Pluto LNG Development, Burrup Peninsula

Woodside Energy Ltd

**Report and recommendations
of the Environmental Protection Authority**

**Environmental Protection Authority
Perth, Western Australia
Bulletin 1259
July 2007**

■ **Figure 5 Predicted Footprints for Sedimentation from Turning Circle and Trunkline Dredging with Estimates for Potential Coral Loss**

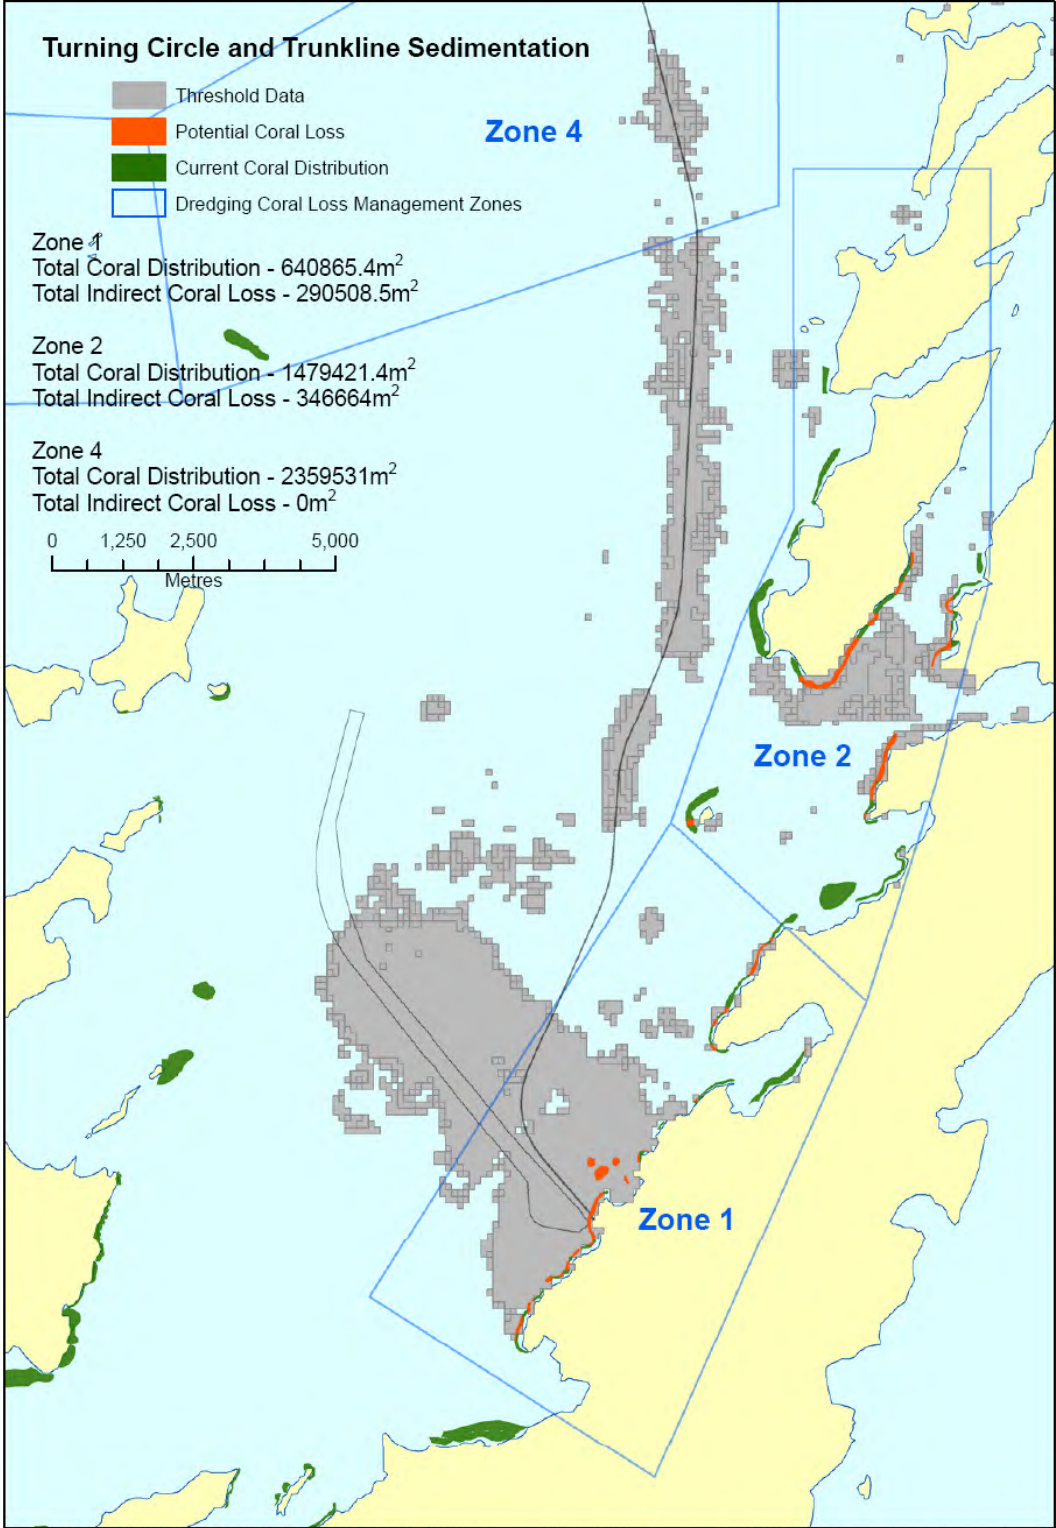
If those observations are applied to **Figure 5** which shows the zone of potential loss based on the new thresholds derived from baseline data it appears the new thresholds represent a gross exaggeration of the zone of potential loss. On the basis of water quality impacts within a distance of 1-1.5 km and mortality within 250 m of dredging the size of the zones of potential loss and of impact would be negligible.

■ **Figure 7 Benthic Habitats at West Lewis Island Tip (MScience 2007c)**

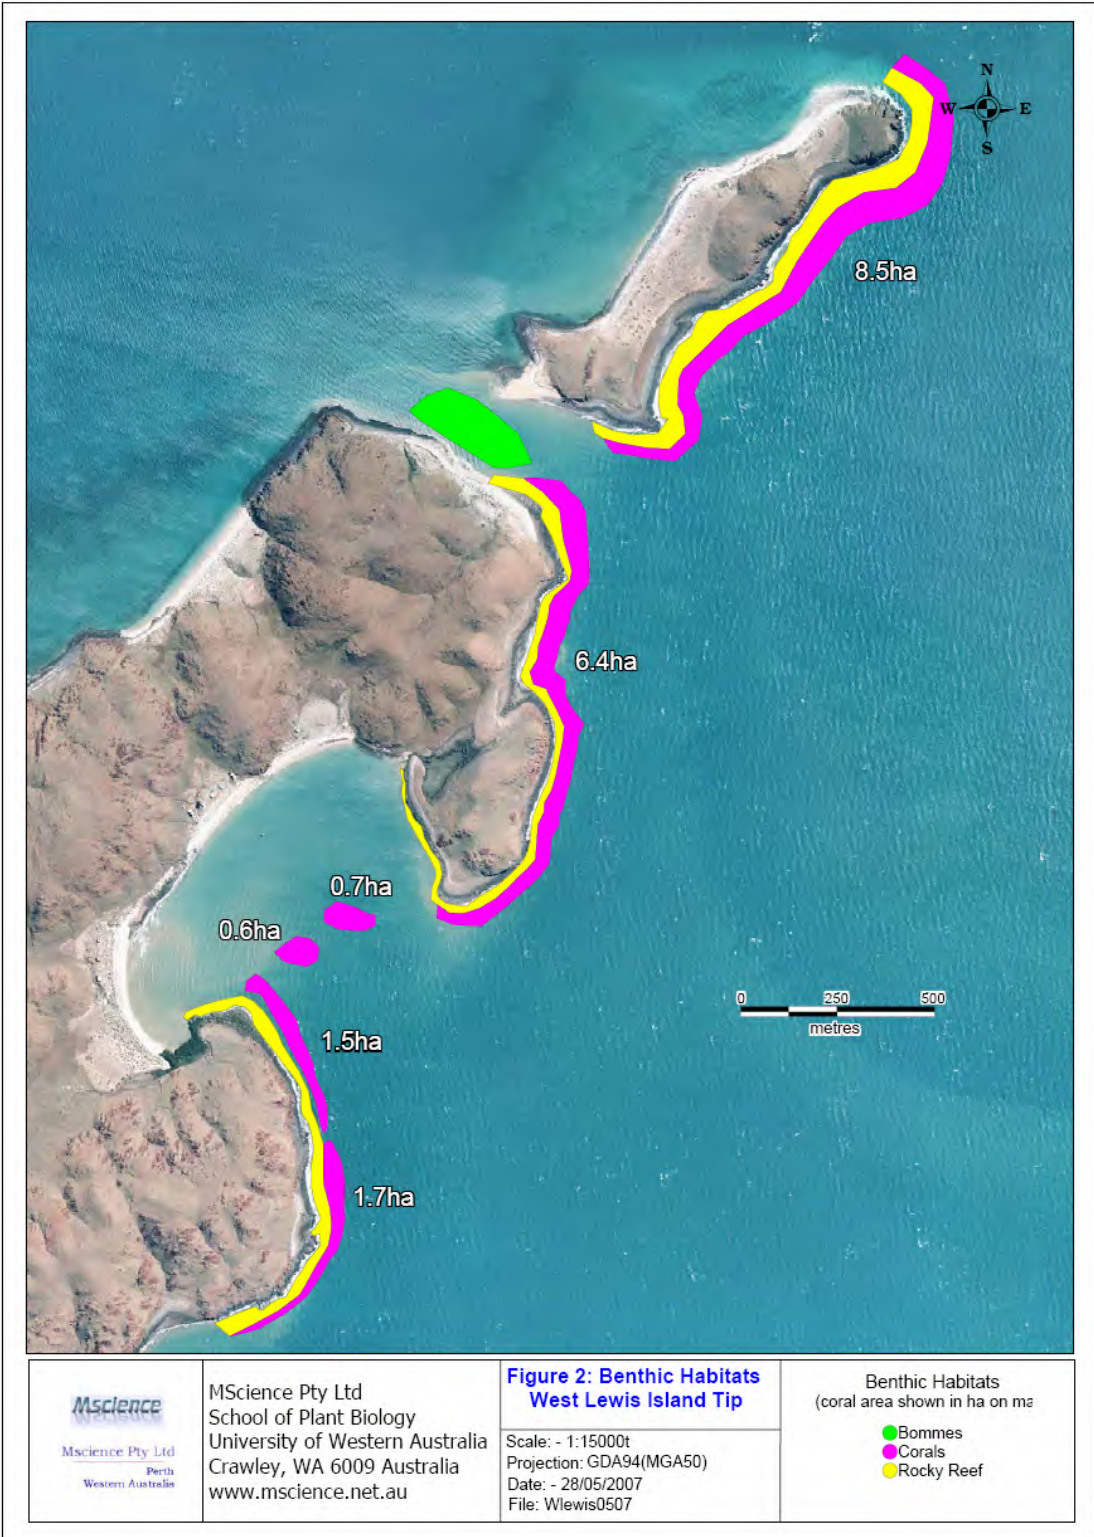
A comprehensive benthic habitat map has not been provided. The habitat map provided only covers coral communities with >10% cover in any detail, but has not included existing coral communities along the NE coast of West Lewis Island. Mapping should include the soft bottom, platform reef and rocky reef substrates and their associated communities.

*The proponent's response to 'comment 9.25' suggests that there will be no impacts to corals on the west side of Mermaid Sound and refers to TSS modelling results in Figure 8. However the sedimentation modelling results in **Figure A21** (spoil disposal alone) [should this be a ref to A11 and A12, there is no A21] indicate that the acute sedimentation thresholds for sensitive species may be exceeded along the shoreline of NE West Lewis Island where corals are known to occur, but are not mapped. Incorporation of resuspension into the model is likely to exacerbate this effect.*

However, in response to the request for the coral communities on the NE coastline of West Lewis Island to be mapped, they have recently been surveyed by MScience and the resulting distribution map is presented in **Figure 7**. A description of the habitats at this location is provided in MScience 2007c (**Appendix C**).

A habitat map for the shoreline of NE West Lewis Island is provided in **Figure 7** (MScience 2007b).

■ **Figure 8 Revised Macro Algae Distribution in Mermaid Sound (Figure 7-31 of Supplement and Responses to Submissions Document)**

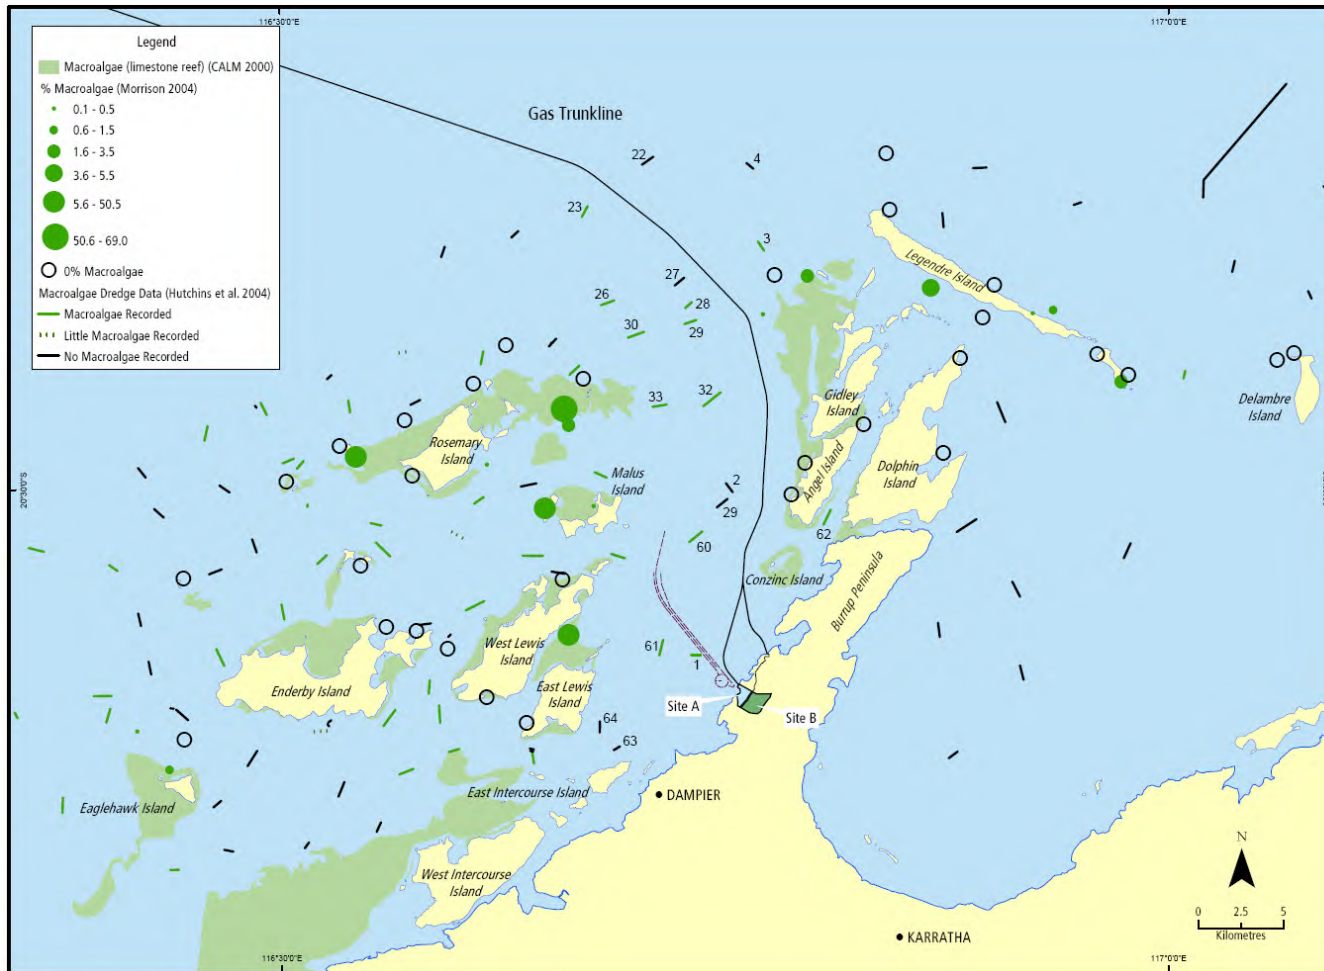
The additional data provided in Figure 7-31 of the Response to Submissions indicates that the extent of the algal community in the vicinity of the areas to be dredged, and the spoil dump sites, may be significant, particularly on platform reefs and other harder substrates. The date of the dredging expedition should be provided.

The additional data provided in Figure 7-31 of the Supplement and Response to Submissions is misleading as an indicator of the presence or absence of Benthic Primary Producer Habitat because it presents the individual samples as ‘transects’. The additional data was collected from a scientific dredging programme undertaken by scientists from the WA Museum in July 1999 and was designed to obtain samples of fauna that could be identified to species (Hutchins et al 2004). A rake box dredge with a mouth area of 1200 mm x 330 mm and mesh size of 10 mm was towed at 2-3 knots for 10 minutes at each of 97 stations. Therefore each strip, or ‘transect’ of the bottom sampled by the dredge was 1.2 m wide and ranged in length from 600-900 m.

The data presented in **Table 12** are the samples that were collected from stations at or near locations where the dredging programme will produce a plume (i.e. in or near the potential zone of influence). Figure 7-31 from the Supplement is reproduced here with the station numbers from **Table 12** added.

If the dredge is not full it is much more indicative of a sparse distribution of macrobenthos, although it is possible the dredge is still not catching everything in front of the mouth. For example, at station 1 (**Figure 8**) the description records very little material and implies the substrate over which the dredge passed was sparsely populated by macrobenthos. It is also interesting to note the presence of *Halophila* spp. at this station could be an artefact as there is no mention of how much seagrass was collected and whether it had been attached to the bottom when collected by the dredge (i.e. roots were attached). This species is quite common in drifts and might have been taken by the dredge from the water column.

■ **Figure 15 Revised Loss Predictions (Figure 5 from Revised Dredging Simulation and Impact Assessment – May 2007)**

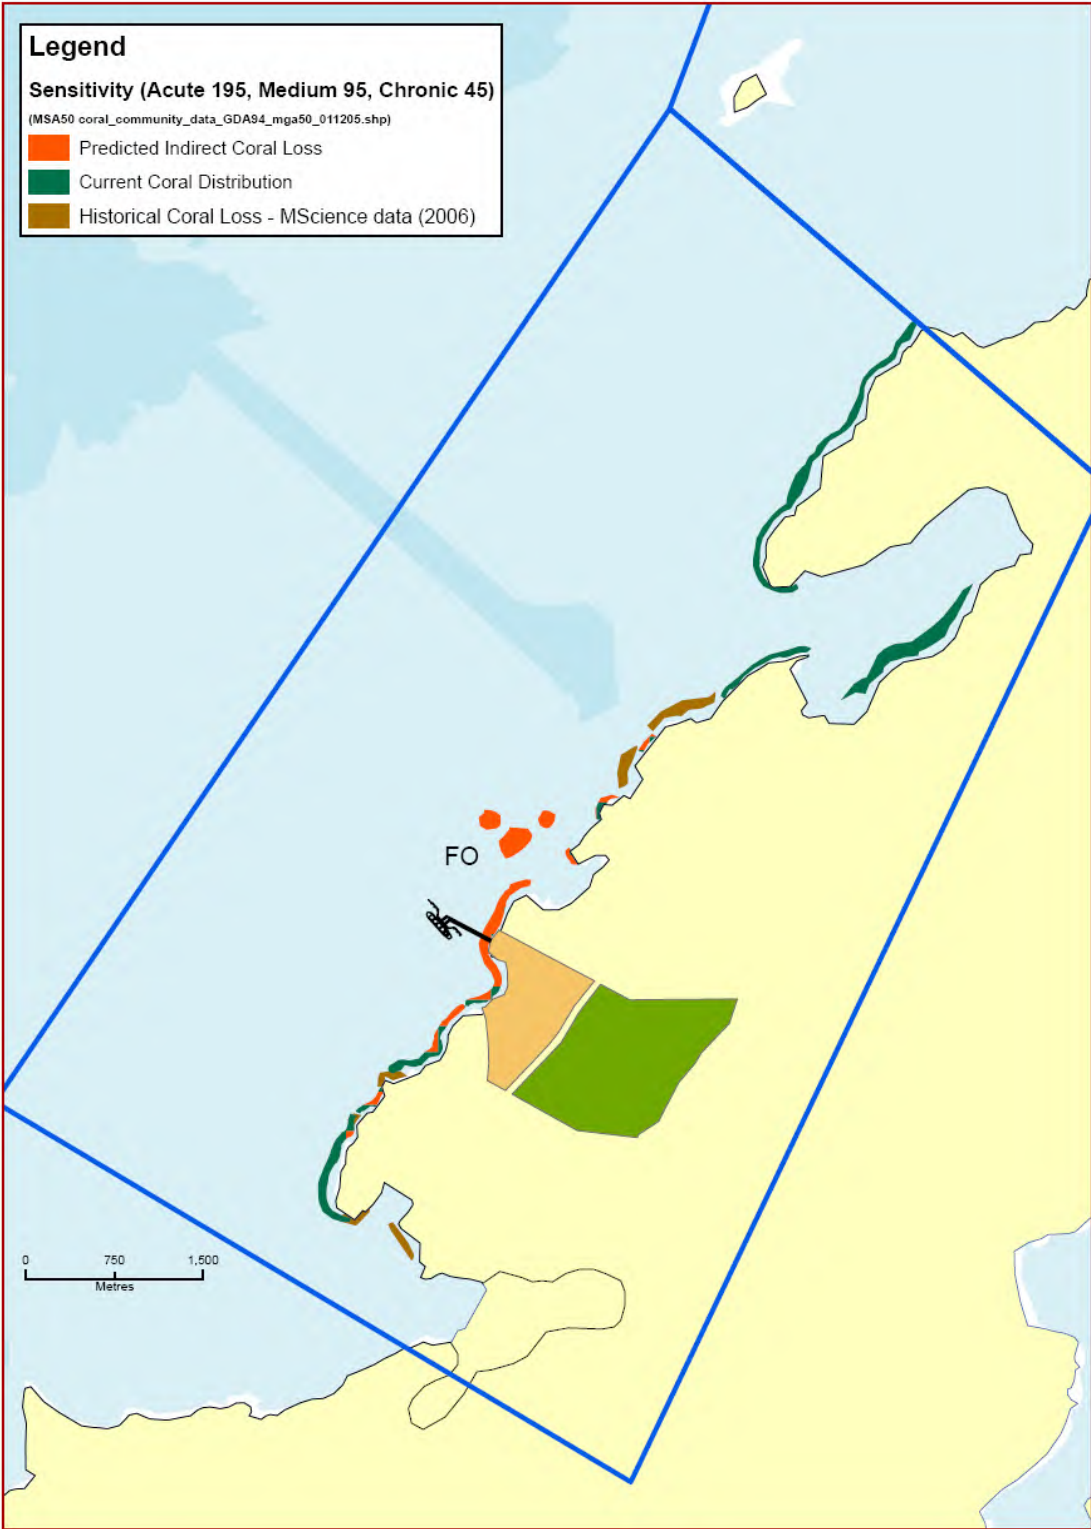
Under the coral impact assessment for Holden Point (Section 4.1.1) there appears to be an error in the calculations for predicted cumulative coral loss resulting from the revised model. It is predicted that cumulative coral loss increases from 42% to 43% (an increase of 1%), however, by scanning figures 2 and 3 it appears that the likely increase in area of coral loss is in the ballpark of 7 - 10%.

It is noted that Section 4.1.1 of the Revised Pluto LNG Development Dredging Simulation and Impact Assessment Report (May 2007), incorrectly states that the revised loss estimate associated with the additional, revised modelling uses the same baseline coral distribution data as were presented in the Draft PER (Figure 4 of the Revised Dredging Simulation and Impact Assessment – May 2007 corresponding to **Figure 14** below). The loss footprint calculations for the revised modelling (Figure 5 of the Revised Dredging Simulation and Impact Assessment – May 2007 corresponding to **Figure 15** and **Figure 16** below) are actually based upon more recent baseline coral distribution data compared to the data presented in the Draft PER. The more recent coral distribution data includes an area of coral habitat identified in Withnell Bay. This additional coral habitat was taken into consideration in above revised coral loss estimates and is the reason why the revised figure for overall coral loss increases by about 1% and not 7-10%.

The areas and percentages used in the calculations that produced the maps of predicted loss depicted in Figure 15 are the original historical loss estimate and the original threshold level and in Figure 16 the sensitivity analysis uses half the original threshold level.
